WATER PERMIT NO. 2675-2

We have reviewed the plans and specifications for your dam repair project (Hendricks No. 4, SD ID No. SD01643) located in the NE ¼ SW¼ of Section 11-T3S-R31E, in Jones County. The plans and specifications for the project are approved. Approval of the plans and specifications does not authorize repair of the dam. The repair of the dam may not begin until Water Permit No. 2675-2 is approved.

**RECOMMENDATION OF CHIEF ENGINEER FOR WATER PERMIT
APPLICATION NO. 2675-2, Travis Hendricks**

REPORT ON
WATER PERMIT APPLICATION NO. 2675-2
Travis Hendricks
October 20, 2011

CROSS SECTION OF DAM ALONG C OF PRINCIPAL SPILLWAY
(Not to scale)

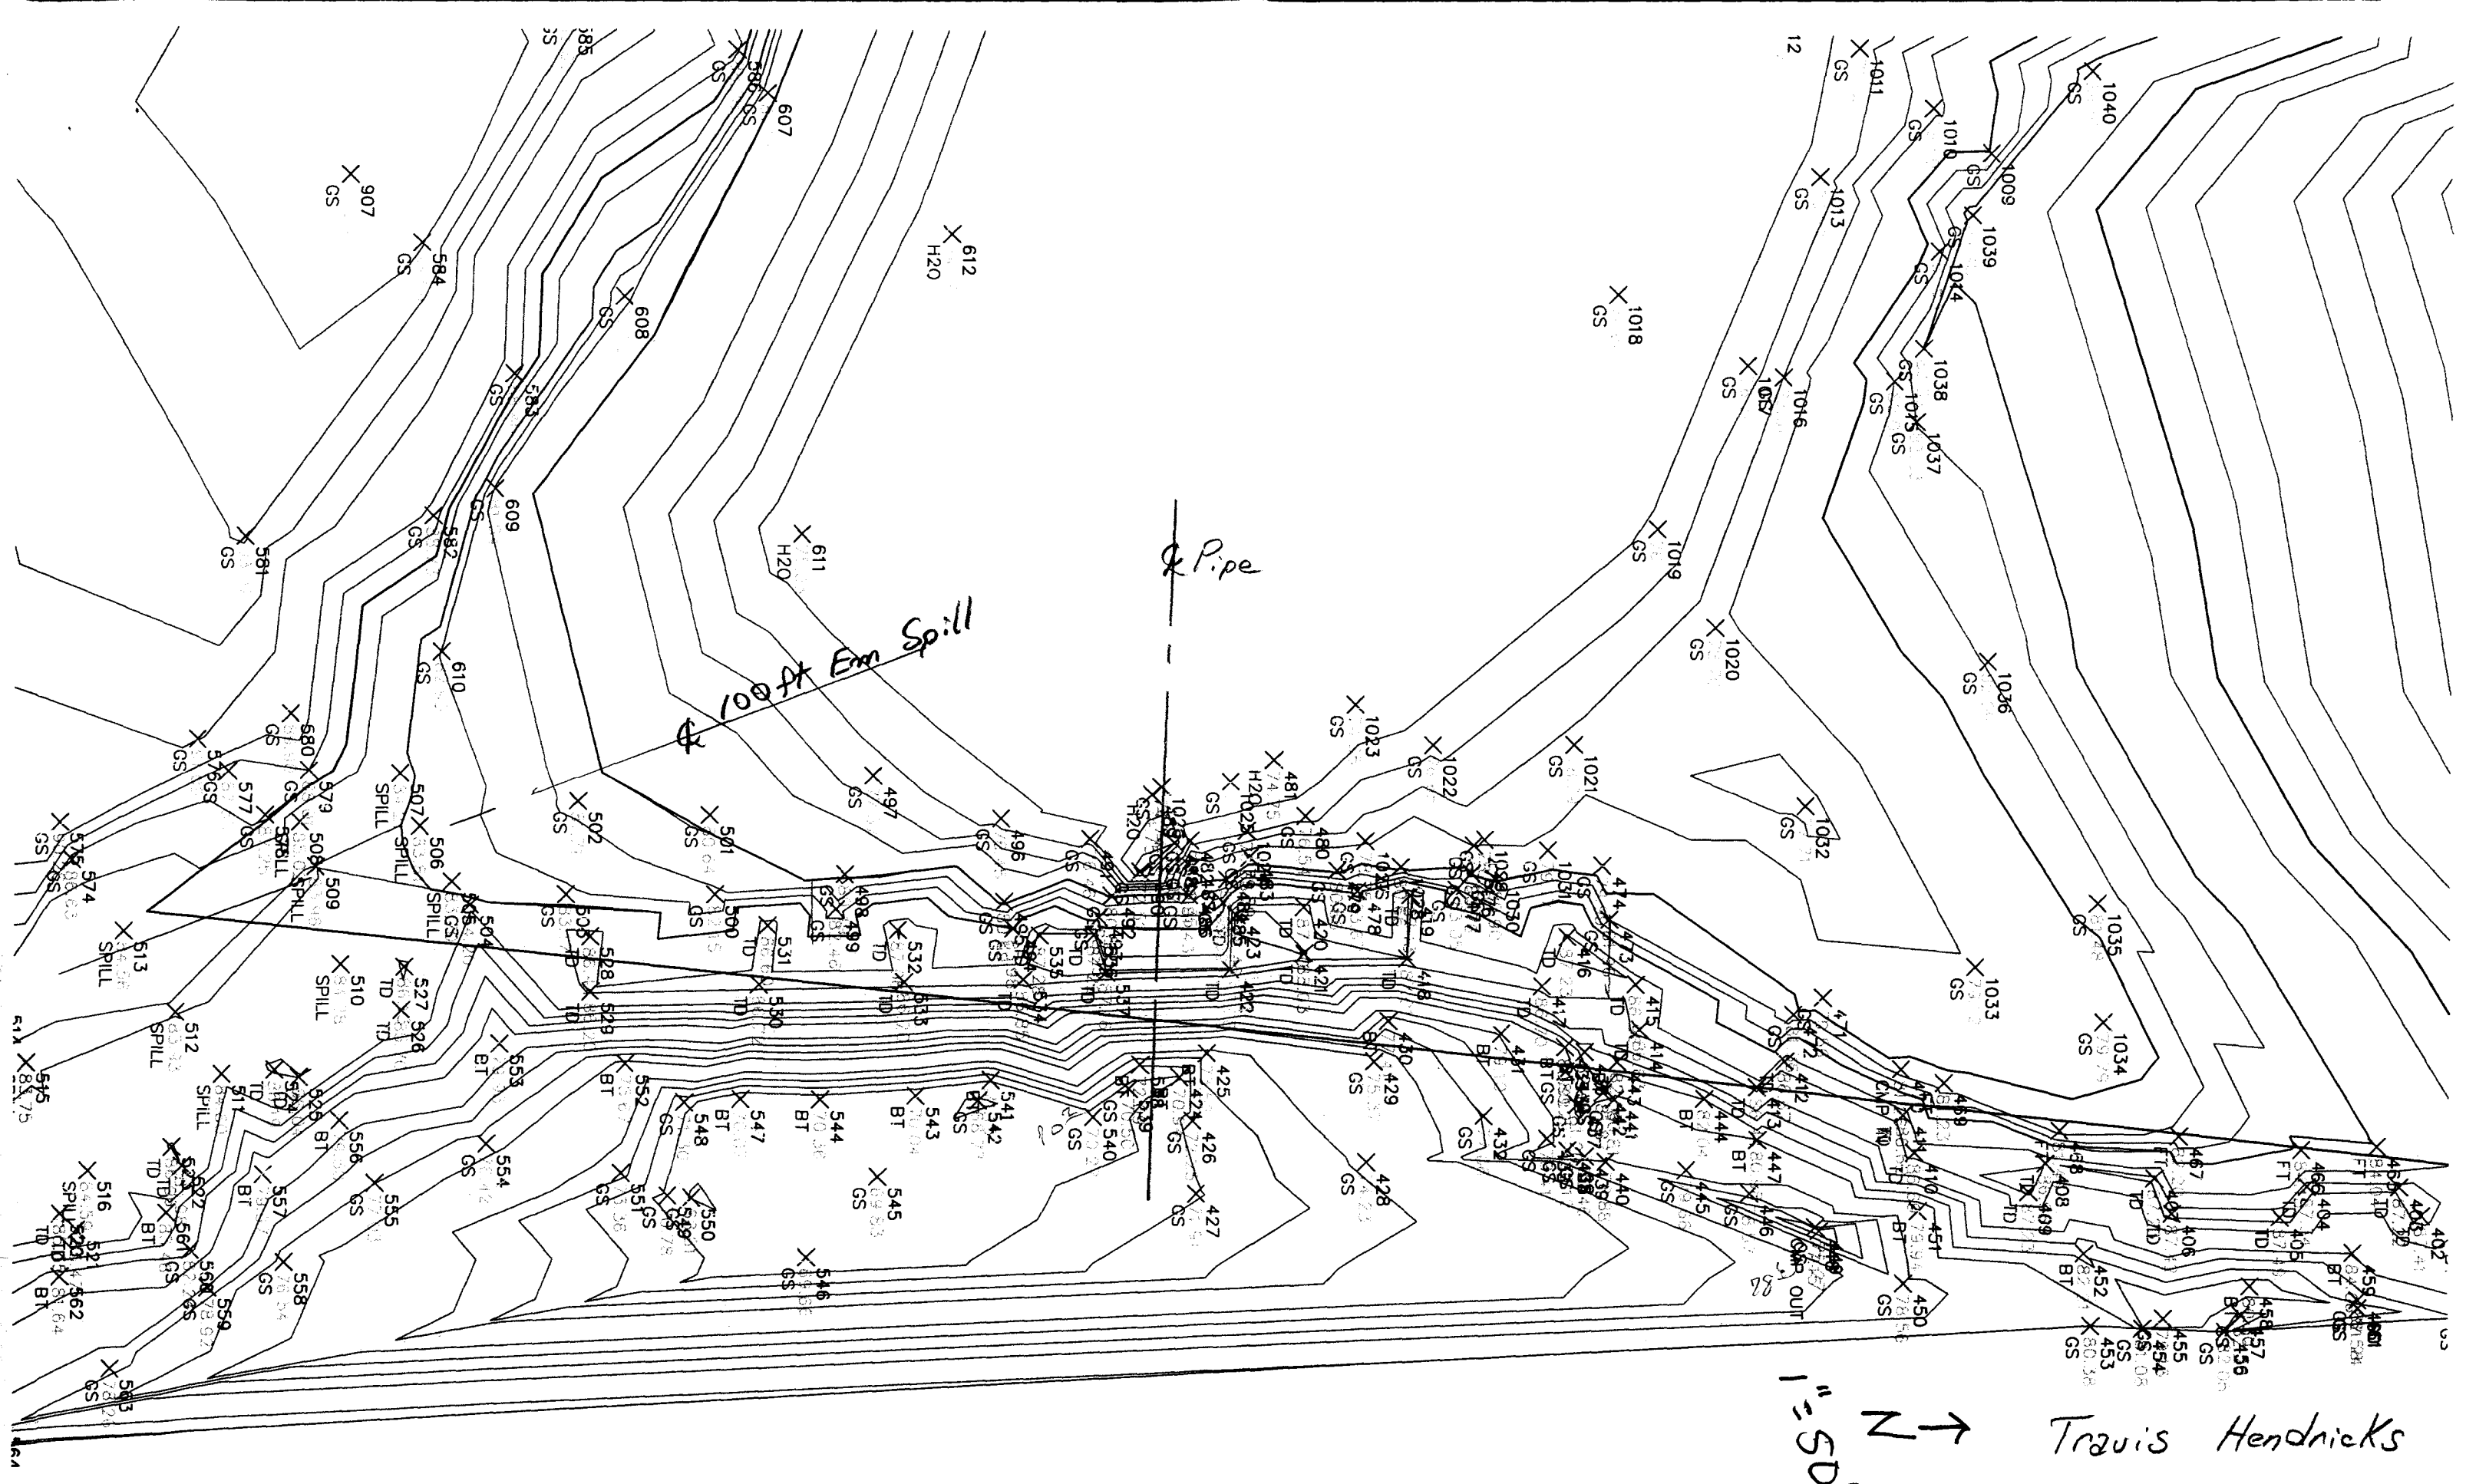
1. Topo Map - OK
2. Dam Axis Profile - OK
3. Dam Max X-Sec. - OK
4. Area Capacity - OK
5. Outlet Details - OK
6. Spillway Rating - OK
7. Spillway Details - OK
8. Specs - OK
9. EPP - N/A - Cat. 3 - OK
